# SAN FRANCISCO PLANNING DEPARTMENT

## Major Permit to Alter Case Report

*Filing Date:* December 6, 2017  
*Case No.:* **2017-014443PTA-02**  
*Project Address:* **335 Powell Street**  
*Category:* Category I (Significant Building, No Alterations)  
*Zoning:* C-3-R (Downtown-Retail)  
80-130-F Height and Bulk District  
*Block/Lot:* 0307/001  
*Applicant:* Lawrence Badiner  
Badiner Urban Planning, Inc.  
95 Brady Street  
San Francisco, CA 94103  
*Staff Contact* Rebecca Salgado - (415) 575-9101  
[rebecca.salgado@sfgov.org](mailto:rebecca.salgado@sfgov.org)  
*Reviewed By* Tim Frye - (415) 558-6625  
[tim.frye@sfgov.org](mailto:tim.frye@sfgov.org)

PROPOSED ROOF PLAN (PARTIAL PLAN)

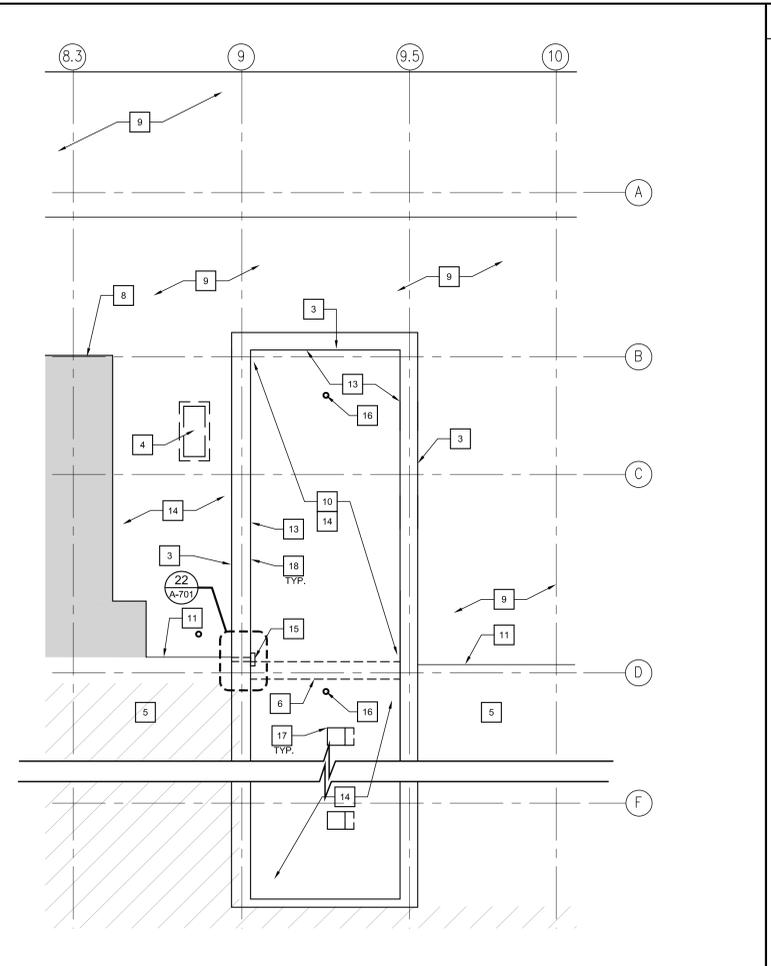
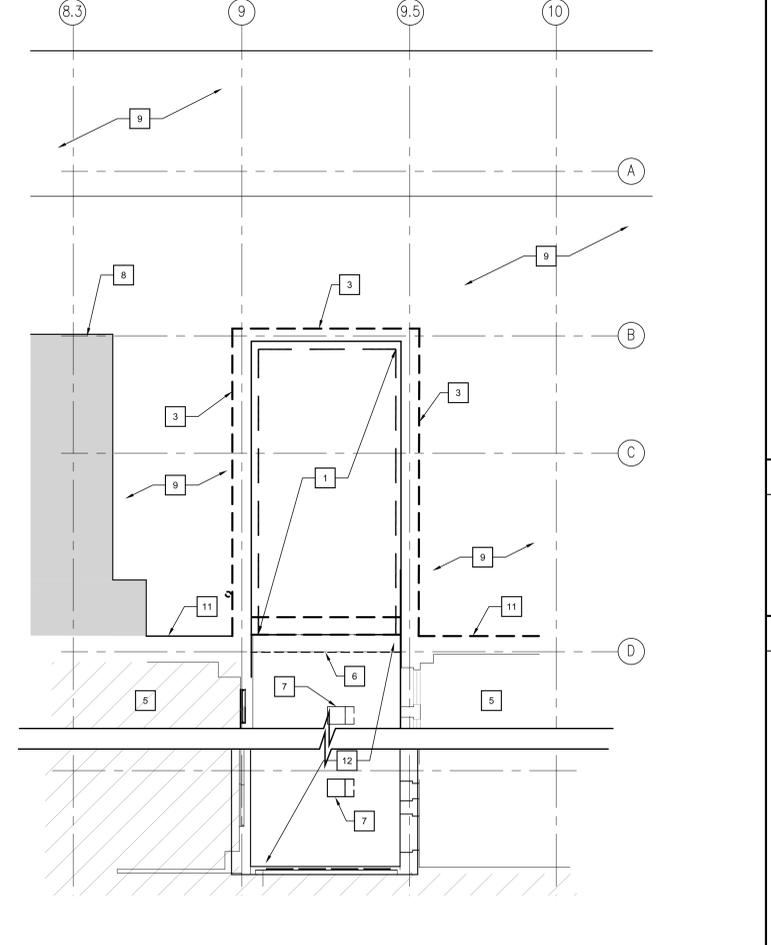
The proposed rooftop mechanical unit will not damage or obscure any significant historic fabric at the subject property. The proposed rooftop mechanical unit will not be visible from a public right-of-way, and could be removed in the future without affecting the form of the historic property.

LIGHTWELL ELEVATION - SOUTH

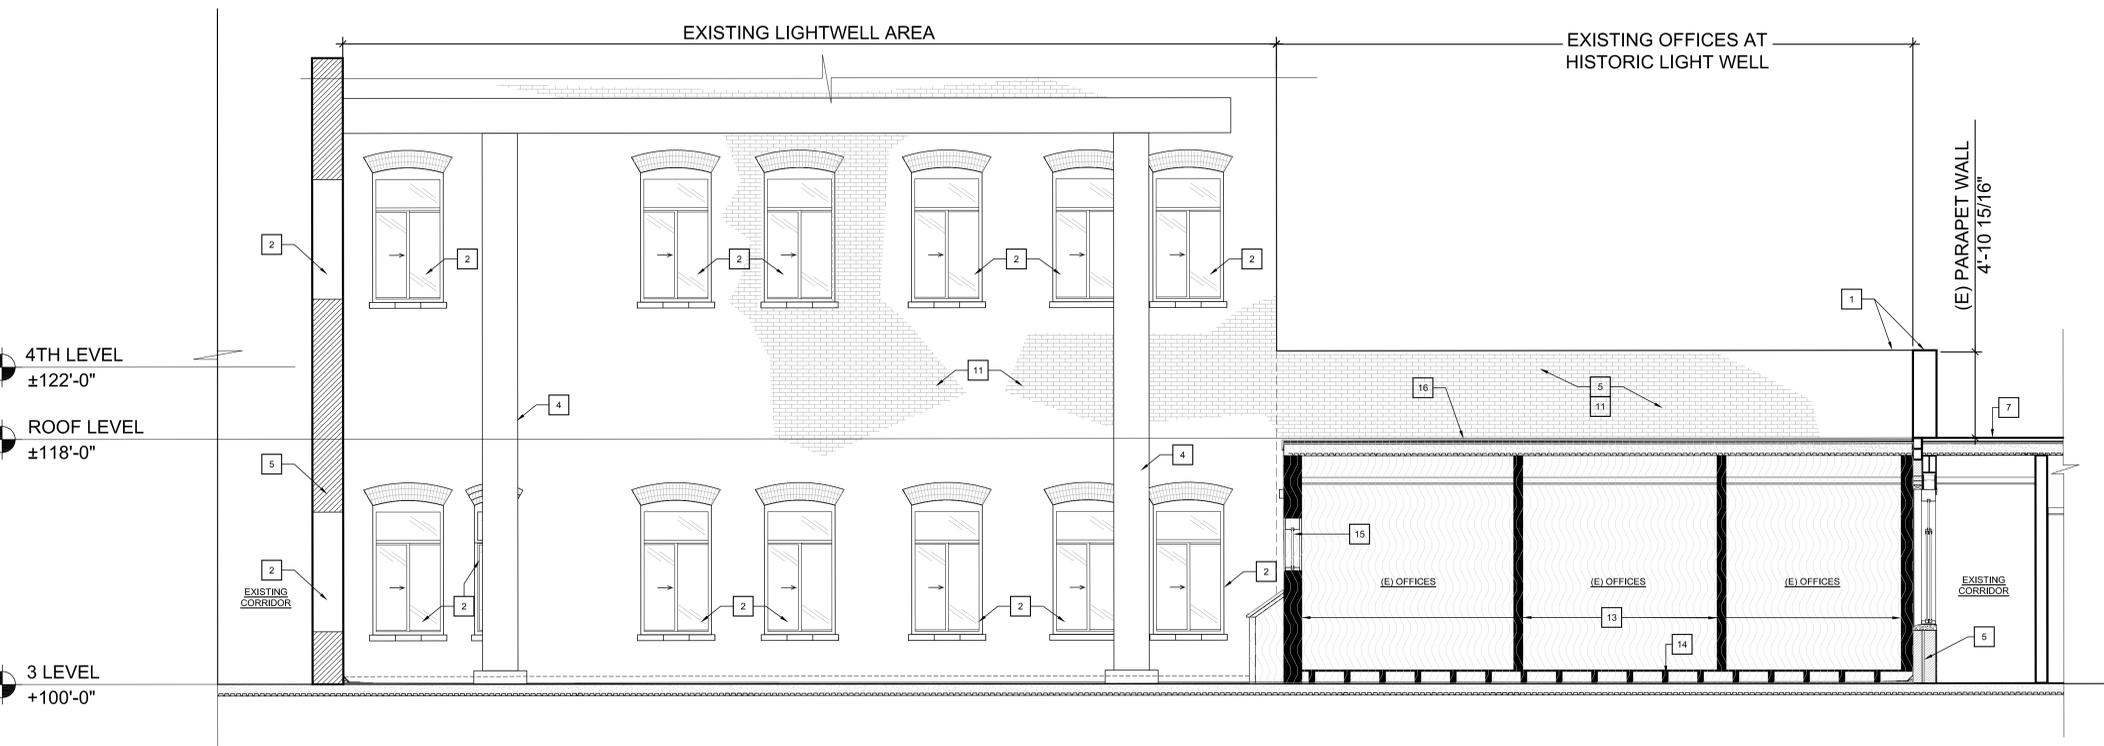
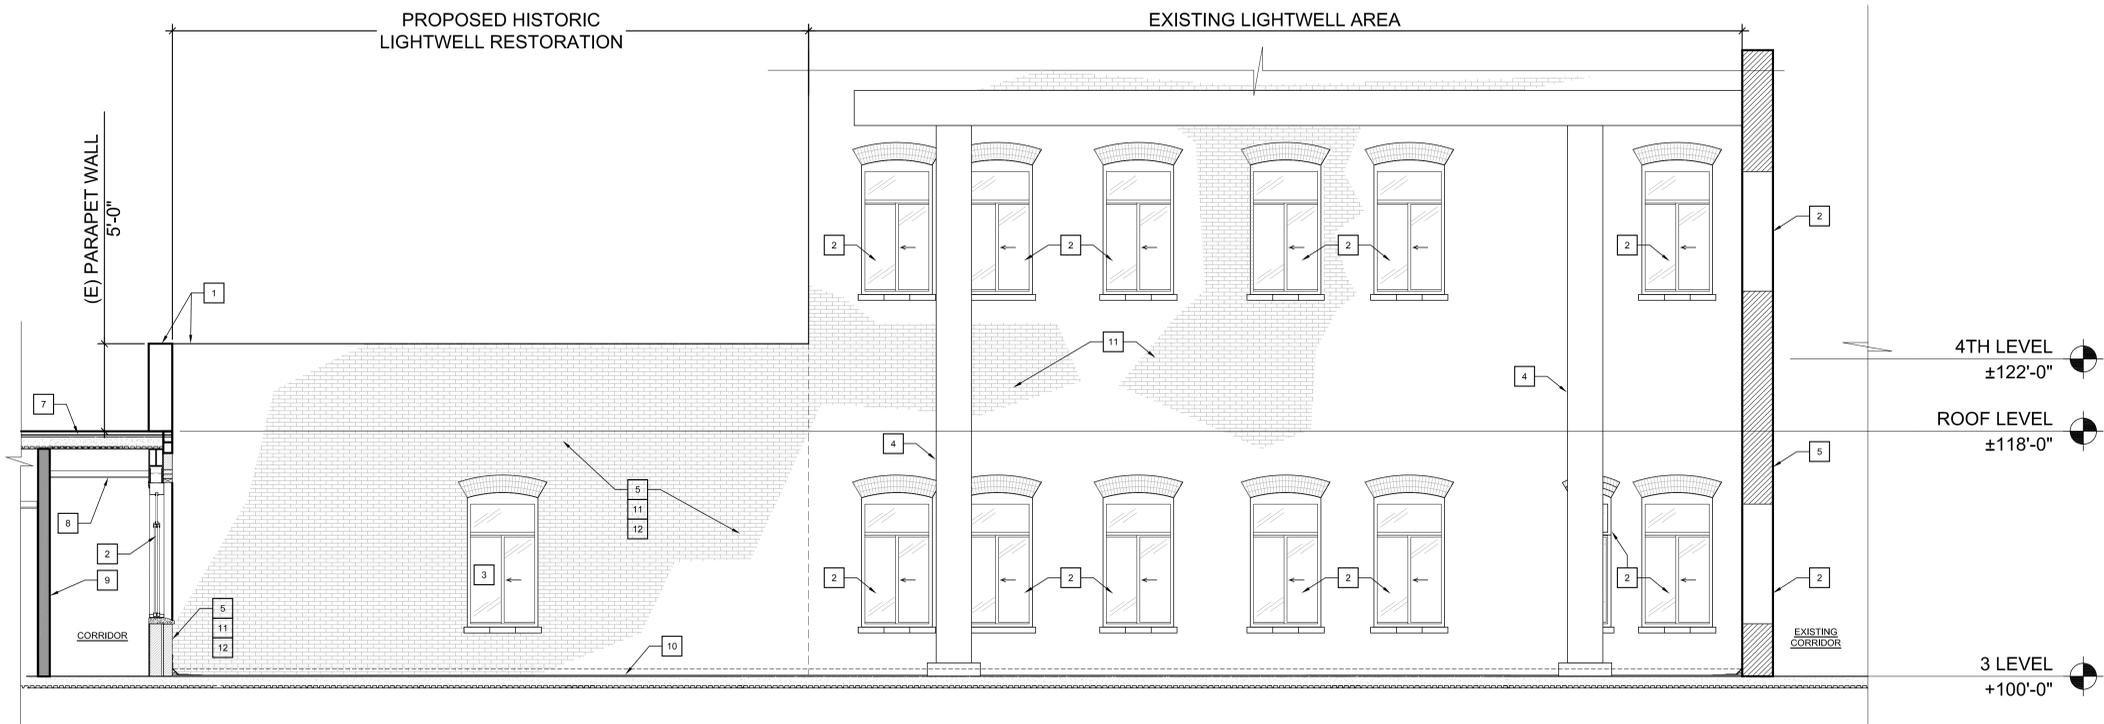
Staff finds that the two new window openings proposed at the north and south facades of the light well will be compatible with the historic windows at the light well, in that they will share similar opening sizes and sill and lintel details, while also being differentiated from the historic windows due to their different materials, operation, and configuration, which will match those of other non-historic windows found at the light well. The new brick cladding to be used at areas of the light well facades where historic cladding is no longer extant will closely match the historic glazed brick cladding, but will also be slightly differentiated to protect the integrity of the property.

1. As part of the Building Permit, the Project Sponsor will notify Planning Department staff once the non-historic one-story addition has been removed to set up a site visit for staff to review and approve the areas where new cladding is proposed to be installed and to clarify areas where repair or replacement of deteriorated historic fabric is anticipated, if any.
2. As part of the Building Permit, the Project Sponsor shall provide to staff a physical sample of the proposed new brick veneer cladding to be used at limited areas of the light well facades.
3. As part of the Building Permit, if any repairs or replacement of existing damaged historic fabric are sought, the Project Sponsor shall provide relevant specifications to Planning Department staff for review and approval.
